Burlington Development Review Board

Development Review Board

Tuesday, May 7, 2024, 5:00 PM

Sheet title: driveway scenario

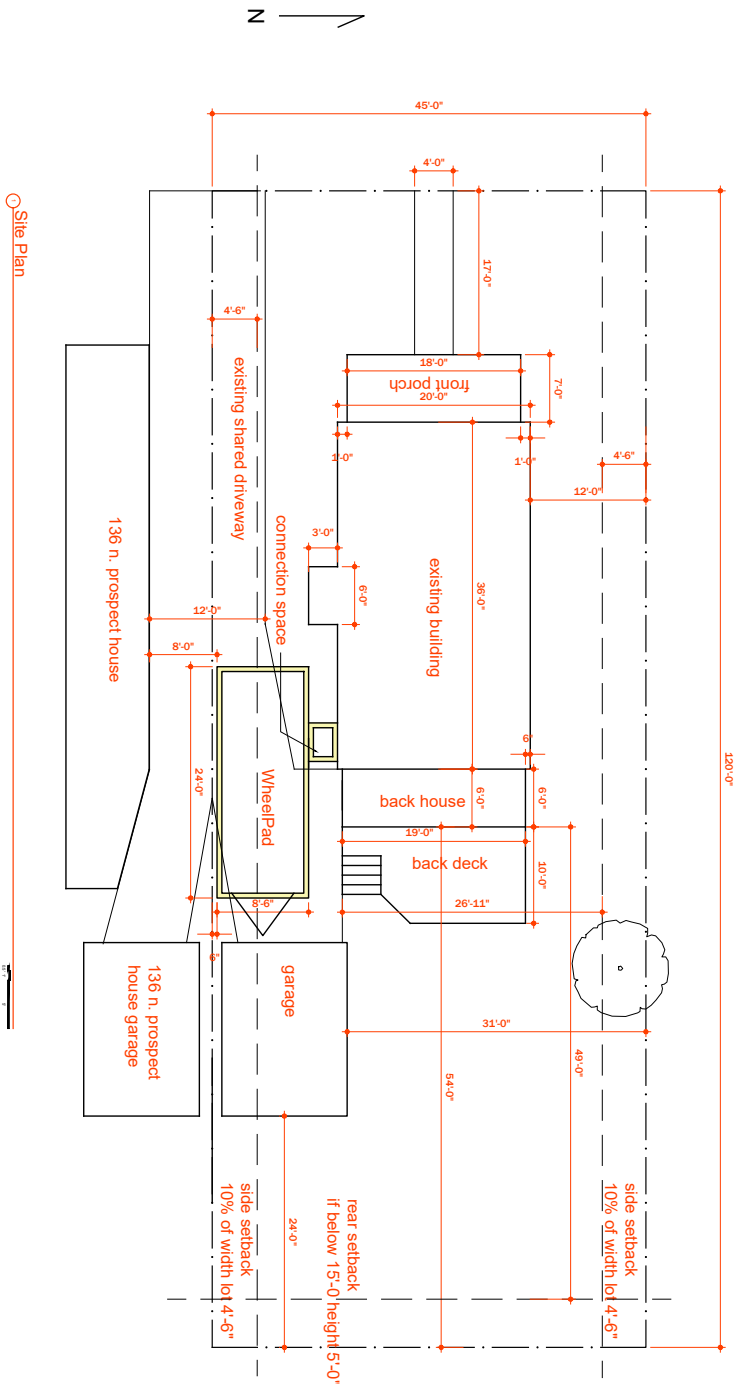
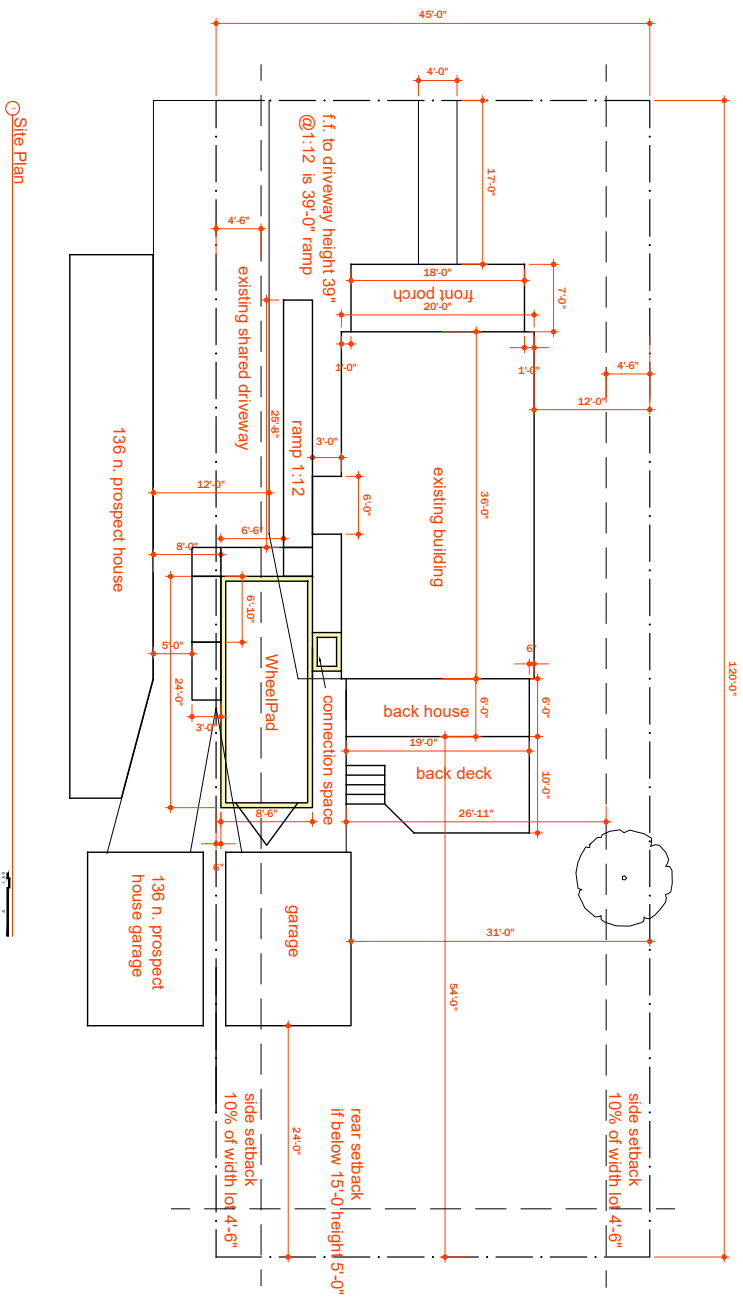
The applicant has provided revised drawings that include several scenarios – one as proposed, one in the driveway, and two in the back yard. The driveway location is compliant with all applicable zoning standards but blocks access to the owner's garage and inhibits use of the shared driveway by neighbors. The two rear yard scenarios are also compliant with zoning standards. Both rear yard installations show removal of the existing back deck and take up space in the back yard. The rear yard installation parallel to the back of the house results in the trailer tongue projecting into the side yard setback; however, this would be permissible per Sec. 5.2.5, *Setbacks, (b) Exceptions to Yard Setback Requirements*. This particular scenario also appears to leave more of the back yard as useable space than the alternative perpendicular rear yard installation. The revised project plans also include an interior renovation scenario. The applicant notes this option would be expensive, disruptive, and time consuming. The revised plans depict compliant options. **(Adverse finding)**

Sheet title: parallel backy and scenario

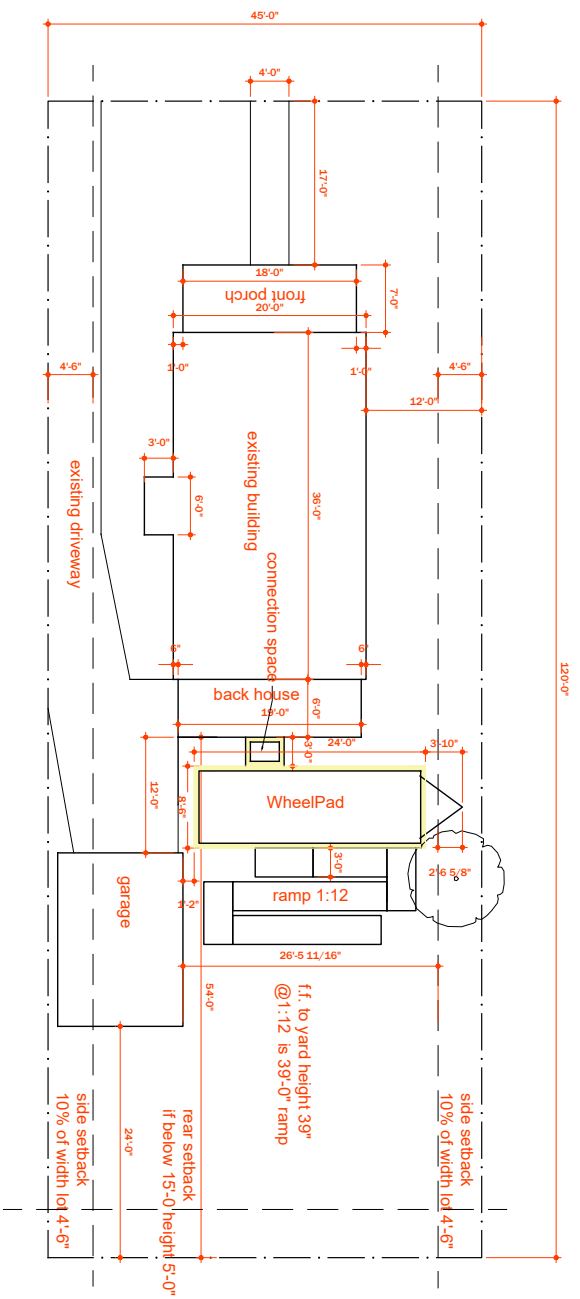
- S301 if possible to maneuver the WheelPad into the backyard parallel to the rear of the house;
- We would have to remove the back deck
- Due to the overhang of the garage roof the WheelPad needs to be situated 14 inches to the north of the garage which places the trailer tongue into the setback as shown in the drawing making this not possible without a variance.
